# UNITED STATES PATENT AND TRADEMARK OFFICE

APPLICATION NO.	FILING DATE	FIRST NAMED INVENTOR	ATTORNEY DOCKET NO.	CONFIRMATION NO.
10/757,047	01/14/2004	Heinrich Kladders	1/1449	4842

**Office Action Summary**

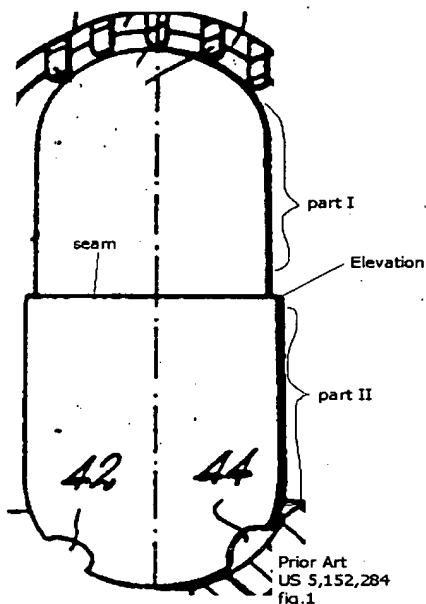
As to **claim 4**, Valentini teaches the method according to claim 1 wherein the capsule has elevations on its outer surface (see labeled fig.1, attachment below).

- As to **claim 6**, Valentini teaches the method according to claim 1 wherein the capsule consists of two parts (see labeled fig.1, attached below) which can be pushed telescopically one inside the other along the longitudinal axis (fig. 1 of Valentini clearly depicts two parts of capsule (22) pushed telescopically).

As to **claim 8**, Valentini lacks the explicit teaching of wherein the capsule has tapering sealed ends. However, it should be noted that Valentini teaches a capsule where an upper and lower parts are sealingly engaged (see labeled fig.1, attached below) by the nature of upper and lower parts' diameter sizes. The narrower diameter upper part (part I, see labeled fig.1, attached below) of capsule 22 is considered tapering sealed end. Thus Valentini teaches wherein the capsule has tapering sealed ends.

- As to **claim 9**, Valentini teaches the method according to claim 6 wherein the seam created between the two parts of the closed capsule is offset from the center by 0 to 12% of the outer longitudinal length (see labeled fig.1, attached below).

As to **claim 10**, Valentini teaches the method according to claim 1 wherein the capsule comprises a member of the D- symmetry group in terms of its outer contour, irrespective of the seam between the two parts of the capsule and irrespective of any manufacturing tolerances (see labeled fig.1, attached below).

As to **claim 17**, Valentini teaches a capsule (fig.1, 22) for holding a pharmaceutical composition which, in the closed state, has a longitudinal axis and a transverse axis which is shorter in relation to the longitudinal axis (see fig.1, 22) and which consists of two parts which can be pushed telescopically inside one another along the longitudinal axis (see labeled fig.1, attached below), wherein the features forming the outer contour of the closed capsule are symmetrical with respect to a transverse plane which bisects the longitudinal axis, the following features being excluded from the conditions of symmetry (see labeled fig.1, attached below): fine structures of the seams which are produced by the sealing of the seams of the individual parts of the capsule, and/or elements formed on the capsule surface which are smaller than 0.1 mm, and/or angles of taper up to 5° (see “elevation” in the labeled fig.1, attached below).

As to **claim 18**, Valentini teaches the capsule according to claim 17 wherein the seam created between the two parts when the capsule is closed is offset from the center by 0 to 12% of the outer longitudinal length (see labeled fig.1, attached below).

As to **claim 20**, Valentini teaches the capsule according to claim 17 wherein features located on the outer contour (see labeled fig.1, attached below) of the capsule surface and forming a symmetrical pair may have a tolerance and inaccuracy deviating from the symmetry of 0.15 mm in each case (see labeled fig.1, attached below).
